MEMO

RE Buildings A1 & A3, National Capital Business Park
4055 Russell Road, City of Ottawa
Transportation Impact Assessment Memorandum – 2nd Submission

TO Wally Dubyk, C.E.T.
Transportation Project Manager, City of Ottawa

04 SITE PLAN
SPA-01 SCALE: 1:1000

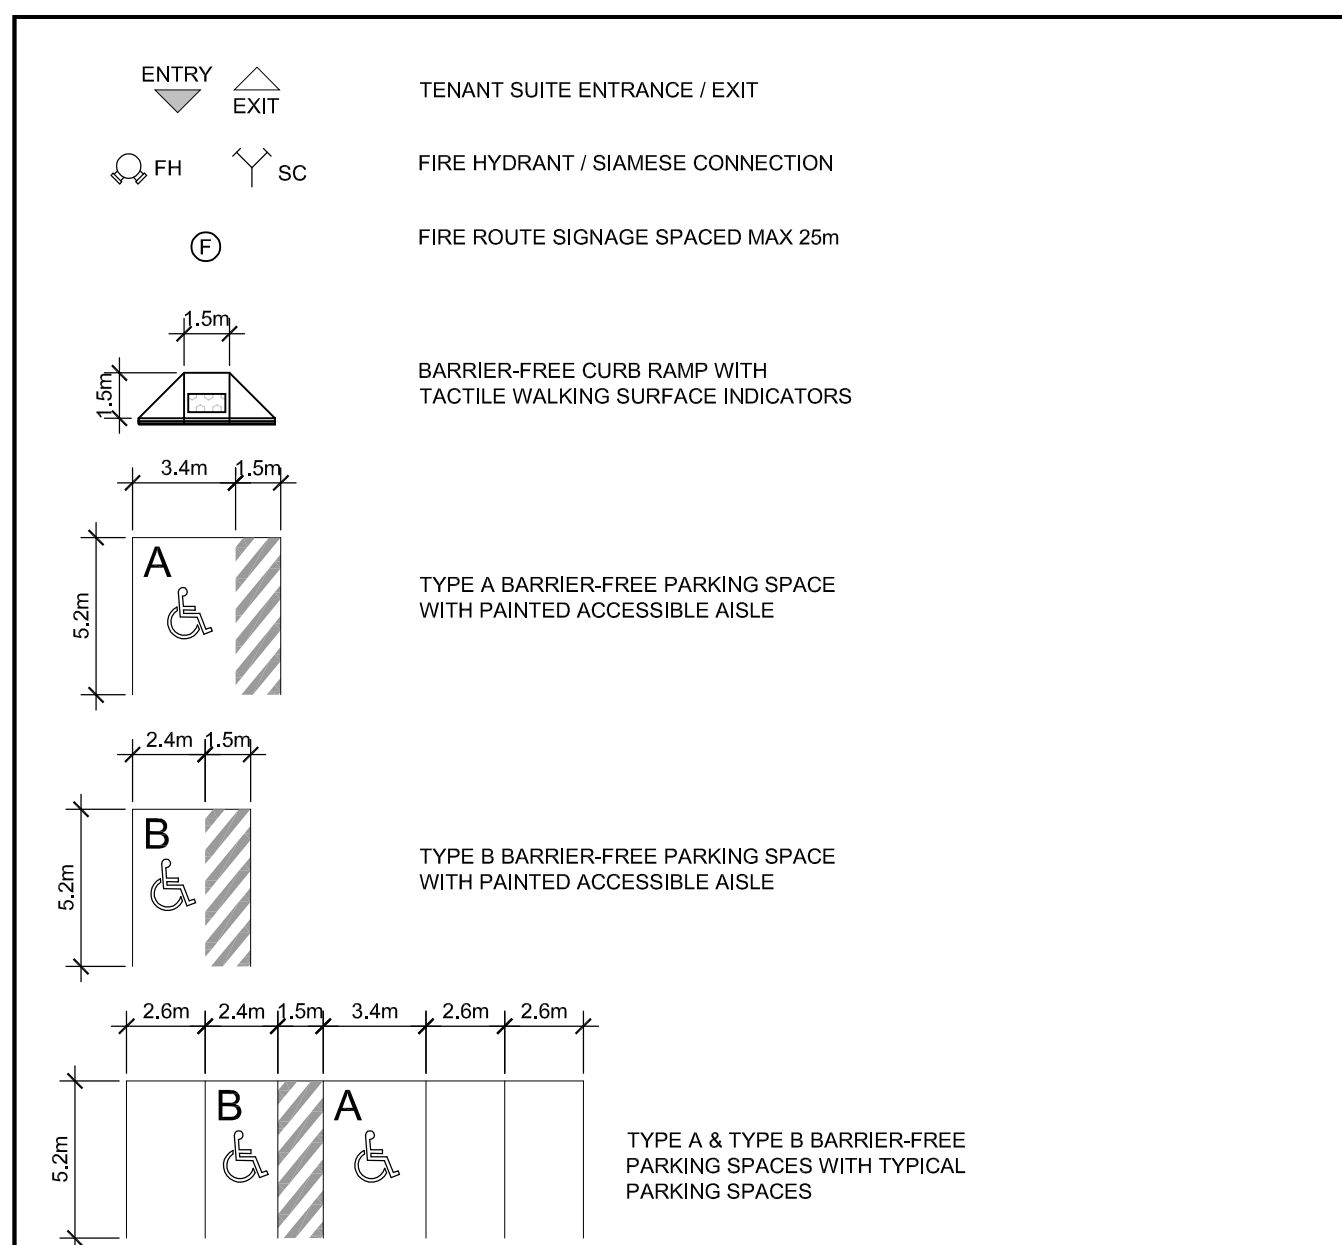
Outstanding	Site Plan	SPA-01 Rev. 05	Mandatory for Approval	Wally Dubyk	Provide pathways and crosswalks from all parking areas to the nearest building entrances to improve safety.	Noted and captured on the latest site plan.
Outstanding	Site Plan	SPA-01 Rev. 05	Mandatory for Approval	Wally Dubyk	To encourage and support the transit trips forecasted, provide a bus pad for bus stop ID 3335 located on Russell Rd along the site frontage. Provide a pathway connection from the bus stop to the closest main building entrance. Alternative locations in consultation with Transit Services for Stop 3335 can be considered should they better align with the site frontage.	Noted. A pad is currently already provided at the intersection of Russell Road and Logistics Private (main access).
Outstanding	Site Plan	SPA-01 Rev. 05	Mandatory for Approval	Wally Dubyk	On Appendix H, outbound trucks appear to encroach on the opposing east-bound traffic lane on Russell Road. Please clarify if this is the case and illustrate what would be required to ensure that trucks do not encroach on opposing lanes. The posted 80km/h speeds and arterial road designation pose a safety concern for overlapping movements on Russell Road.	Noted. This is an existing access and designed to typical TAC standards. Truck encroachment to opposing lanes is common and similar to most of the accesses along the road and in the area. Trucks are expected to wait for sufficient gaps to make the maneuver similar to a left turn that encroaches both lanes. Further, the site is considering LCV trucks as well. Therefore, truck aprons will ultimately be considered as well to accommodate LCVs.

Project: 4055 RUSSELL ROAD (BUILDING A1&A3)
 CITY OF OTTAWA
 Drawing: SITE A1 & A3 EXTERNAL SITE ACCESS
 AND RUSSELL RD
 LCV A-TRAIN MANEUVERING

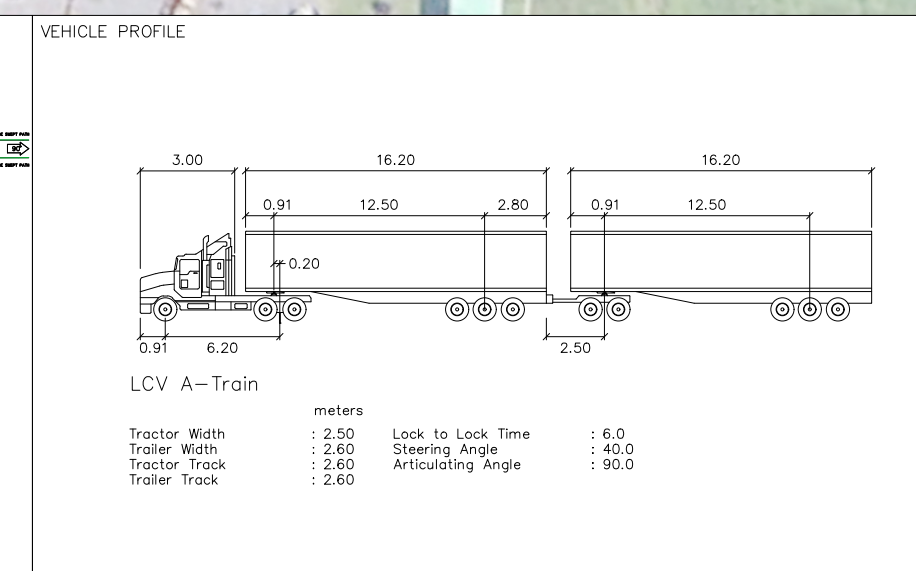
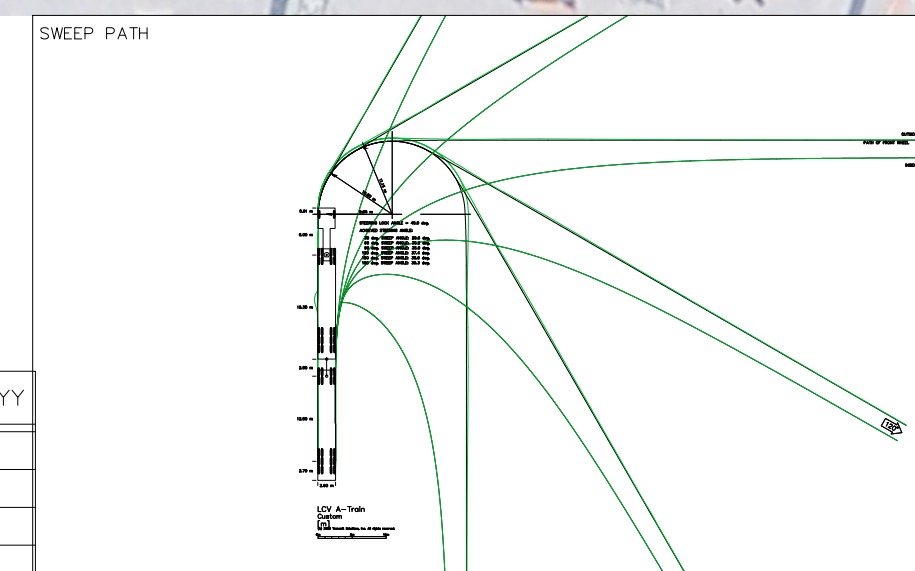
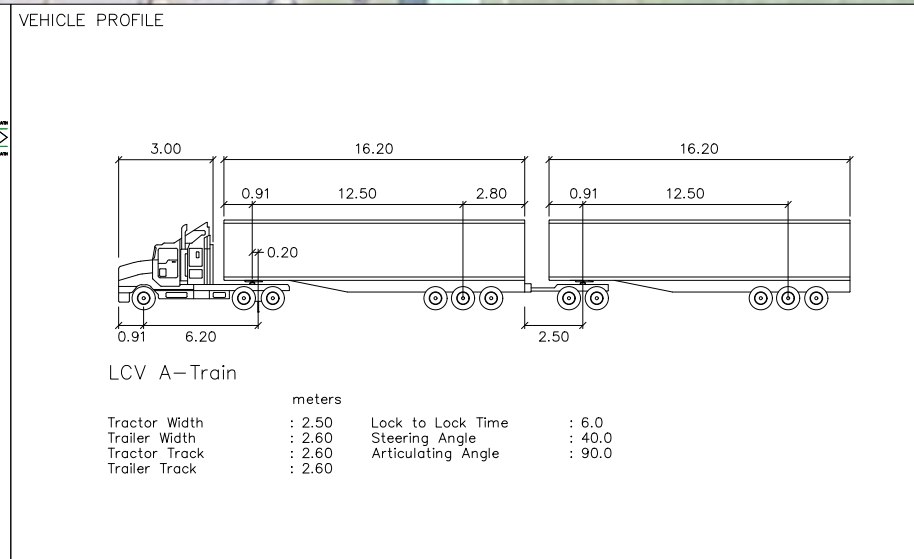
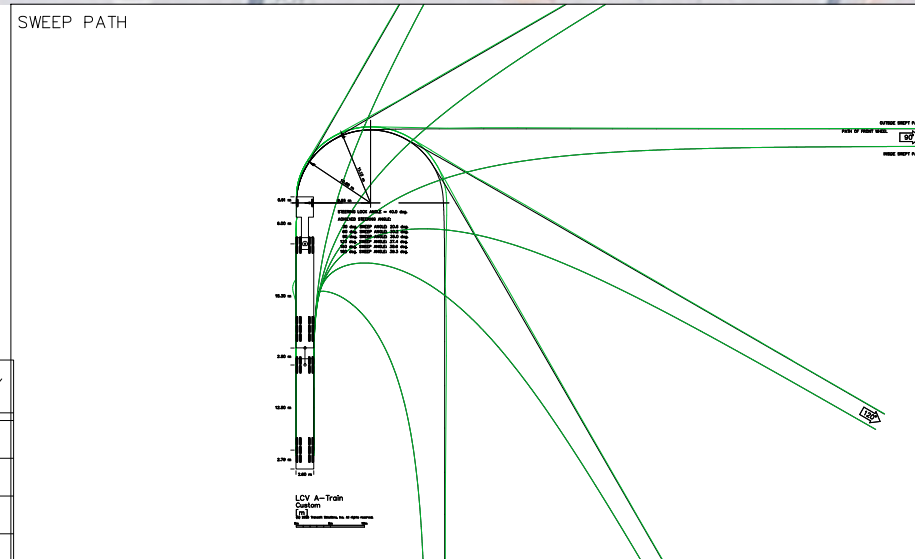
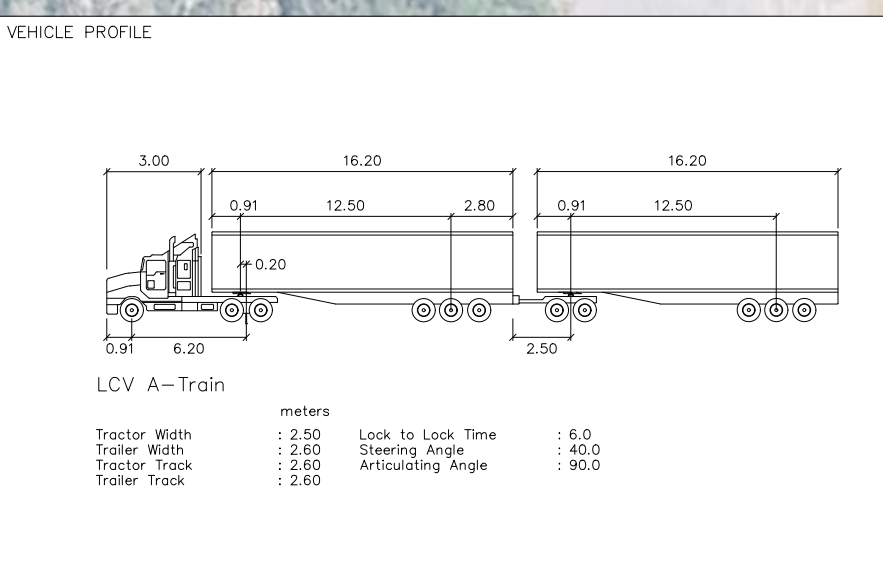
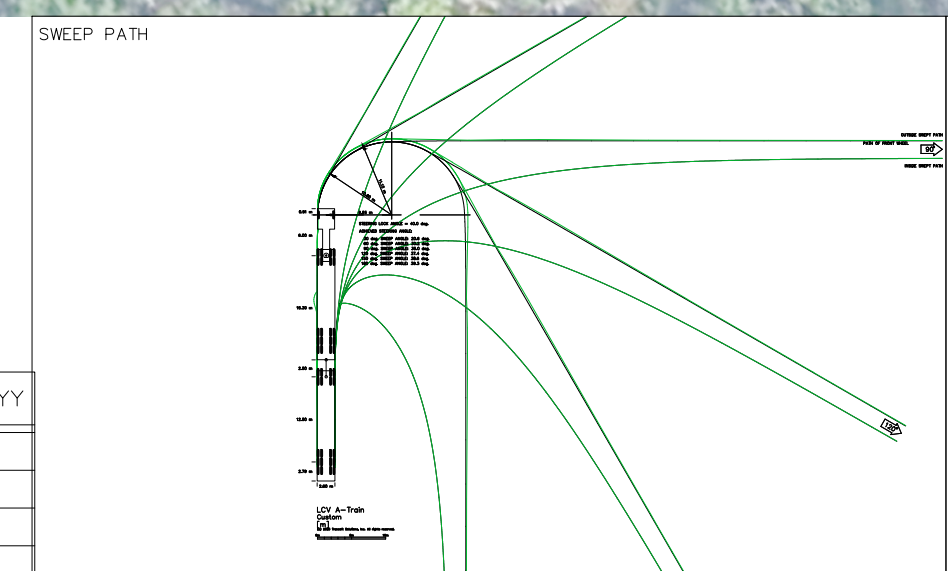
Outstanding	Transportation Impact Assessment	Dated 12/19/25	Mandatory for Approval	Wally Dubyk	Provide turning templates for trucks.	Please refer to the additional swept paths included in Appendix H.
Outstanding	Transportation Impact Assessment	Dated 12/19/25	Mandatory for Approval	Wally Dubyk	Provide elevation of throat length for the accesses per the TAC.	This comment is interpreted to mean evaluating clear throat length of the site accesses. This has been provided in the updated TIA Memo in Section 5.6 .
